Project# 21-1146

At your request, a structural inspection of a deck of the house located at 80 Doonbeg Dr Fuquay-Varina, NC was performed on 05/14/2021 to evaluate the as-built deck in the rear side of the house.

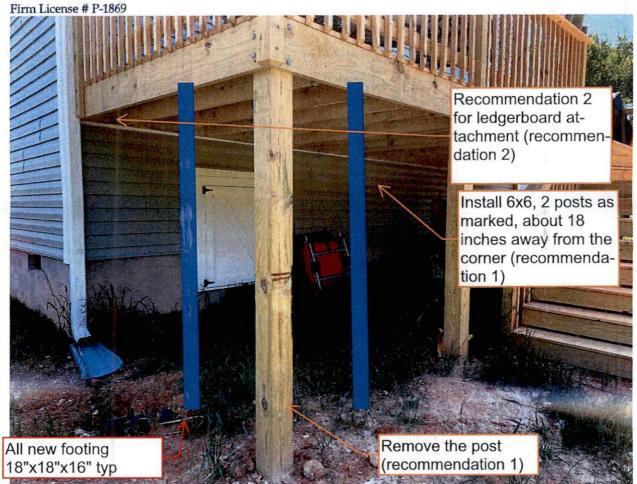
- 1. The right rear corner post of the elevated deck shall be removed and two 6x6 posts shall be installed at a minimum distance required by the town for septic line. We recommend that you install two posts on the two sides of the deck, 18 inches away from the current position. The footing shall be 18"x18"x16" concrete for each post. (2) 2x beam may be left as is making cantilever. The beam(s) shall be connected to new posts using 2 thru bolts. See attached picture for reference.

- 2. The ledger board at the building wall shall be attached using 2 rows of 4" LedgerLok, staggered for the full length. See attached picture for reference.

- 3. Since the deck is more than 4 feet height, install 2x6 bracing on the elevated deck post lines and outmost deck posts using a 5/8" diameter thru bolts. See attached picture for reference.

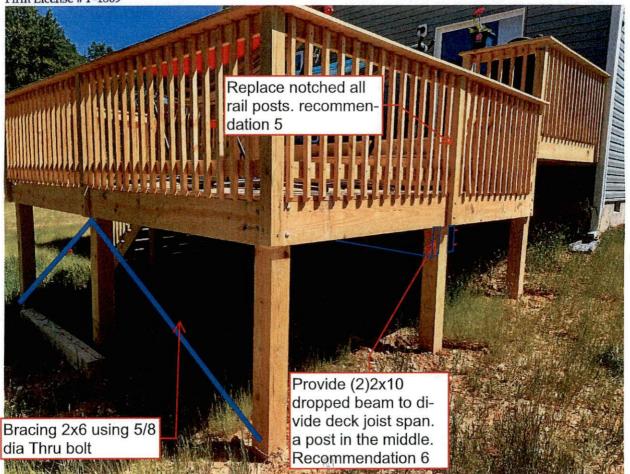
- 4. The rear right corner post of the lower deck shall be removed and two 6x6 posts shall be installed about 3 feet to maintain minimum distance from the septic line. Install Knee brace on both sides to support deck beams. See attached picture for reference.

Provide 2 knee braces to support 3 cantilever deck (recommendation 4)

Install two posts about 3' away from the corner (recommendation 4)

Remove post (recommendation 4)
